PlanGrid Task Report - Mar 20, 2025

#4 [CNTL 503] [NEW] DTT Stat not operational.

IMG_9704
Ian Fuller
Mar 18, 2025 2:55 PM

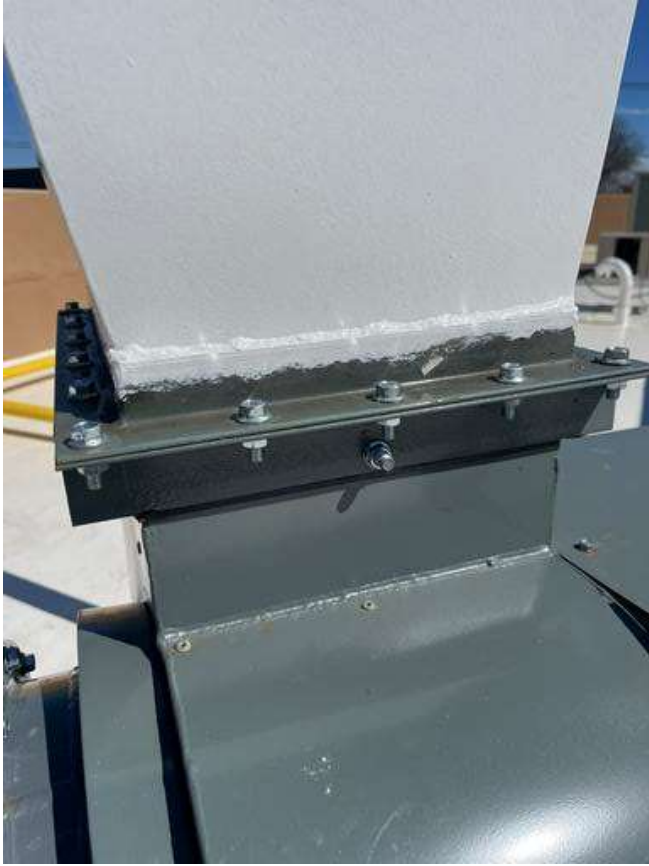
#3 [CNTL 509] [NEW] Ansul pull labeling.

Status	Start Date
Open	Mar 18, 2025
Type	Created
Planned Work	Mar 18, 2025 2:52 PM ianf@nationaltab.com
Description	Last Updated
Need to be labeled with red bakelite label with 1/4" high white letters indicating the hoods served.	Mar 18, 2025 2:55 PM
